SOUTH COAST AIR QUALITY MANAGEMENT DISTRICT ENGINEERING & COMPLIANCE DIVISION APPLICATION PROCESSING AND CALCULATIONS	APPL. NO. 525797	DATE 9/14/11	PAGE 1 of 24
	PROCESSED BY Angelita Alfonso	CHECKED BY

PERMIT TO CONSTRUCT
-Modification-

COMPANY NAME: PARAMOUNT PETROLEUM CORP
 ID No. 800183

As required by Variance Case No. 2914-111, Paramount submitted A/N 525797 to modify the API Wastewater Separator by installing a new fixed roof on the afterbay section of the API and venting the afterbay to a carbon filtration system. Currently, Paramount is not in compliance with Rule 1176(e)(2)(A)(ii), but has not received a Notice of Violation. This modification will bring Paramount into compliance with the rule.

Figure 1: EXISTING API WASTEWATER CONTROL CONFIGURATION

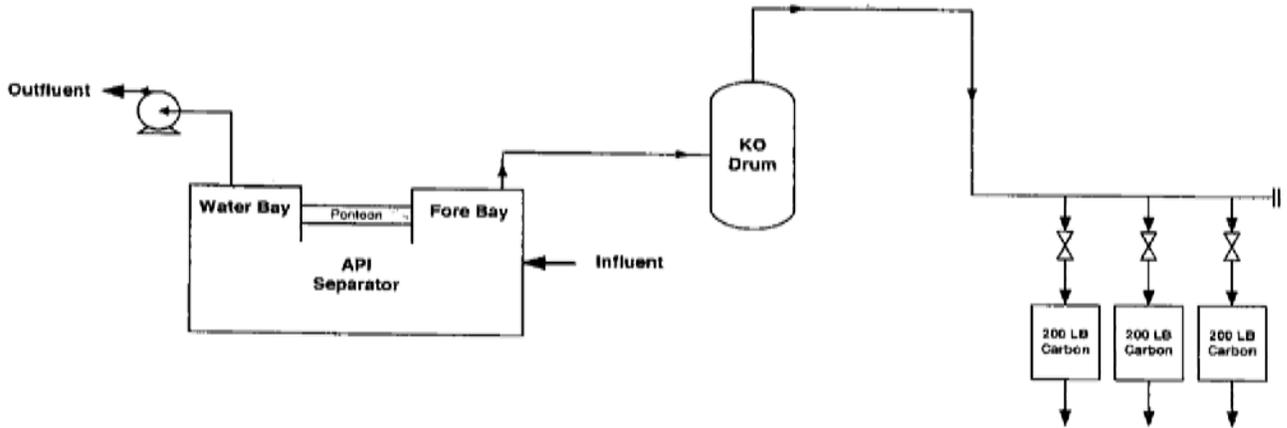
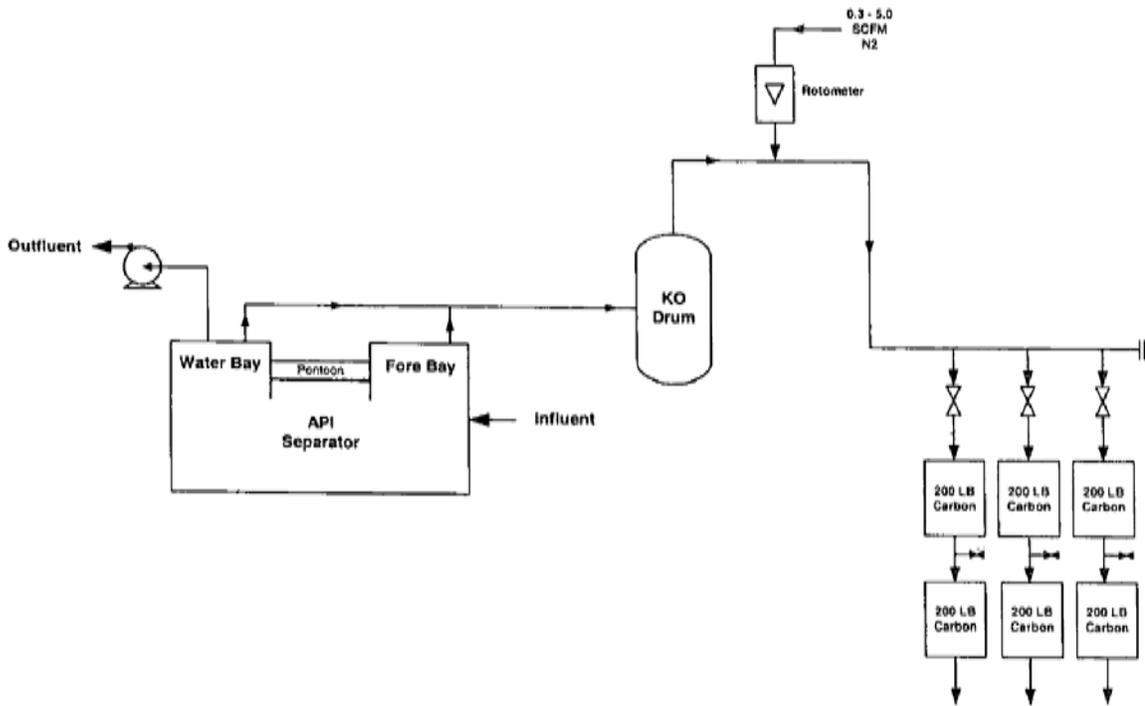
hatches that are sealed with silicon sealant. Under this application, a new fixed roof will be installed on the afterbay section. The new cover will minimize seams and hatches requiring sealant with welded seams and bolted connections and will include a connection to the same knockout pot as the forebay. The three existing carbon drums will be upgraded to a configuration of three parallel sets of two drums in series. In order to extend the life of the carbon drums, Paramount proposes to maintain a nitrogen blanket on the system to reduce moisture content in the vapors. The simplified process flow diagram for the existing and proposed API control is shown in Figures 1 and 2.
